## SERVICE BULLETIN

POWER PLANT - ENGINE - POWERPLANT - INTRODUCE A SPACER AT CLIPPING POINT CP0809 -  
CATEGORY CODE 6 - MOD.ENG-71-0066

# V2500-ENG-71-0066

MODIFICATION OF CLIPPING POINT CP0809  
Fig.1

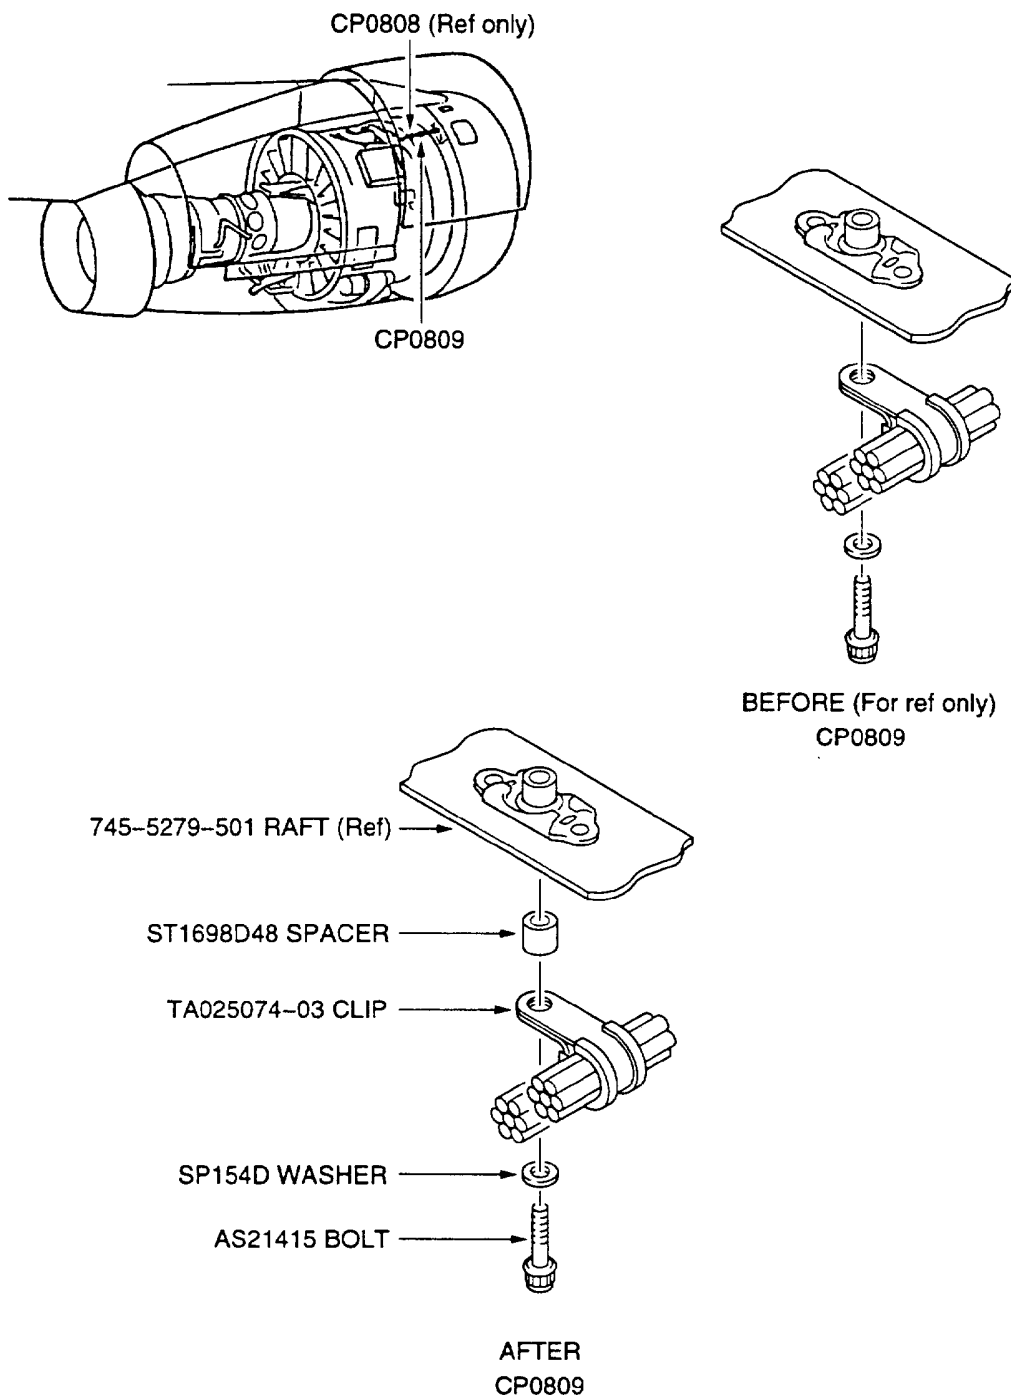
- (a) A spacer is added at clipping point CP0809. The existing bolt is removed and replaced with a longer bolt.

- (1) Assemble clipping CP0809 to 740-5182-501 raft assembly as shown with an AS21415 bolt, SP154D washer, TA025074-03 clamp and an ST1698D48 spacer (Refer to Figure 1.)
- (2) Torque the AS21415 bolt 36 to 45 lbfin (4 to 5 Nm)
